Wheel Horse Service Bulletins 1961 - 1990: **#402** Issued: March 1987

Mower Belt Installation - 37" Side Discharge Mower

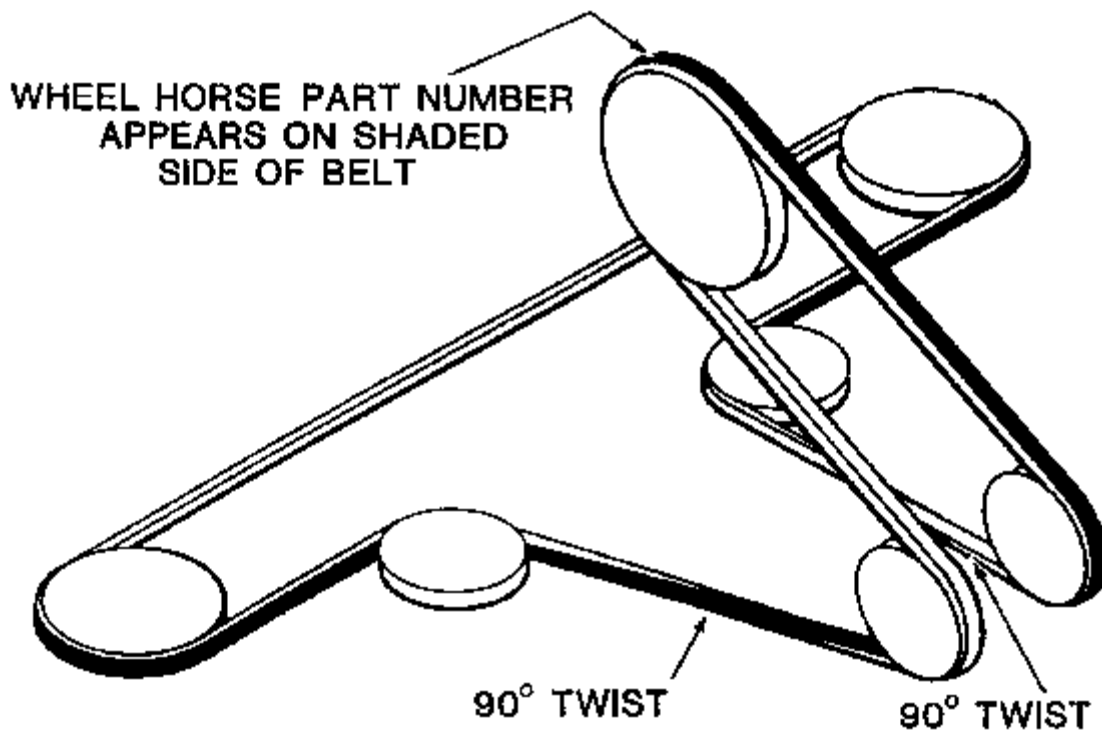
1.2 The above #111178 belt will fail prematurely if improperly installed.

2.1 Refer to the belt routing illustration below for the correct belt routing. NOTE: For reference, one side of the belt has been shaded.

2.2 The Wheel Horse belt part #111178 appears on the shaded side of the belt.
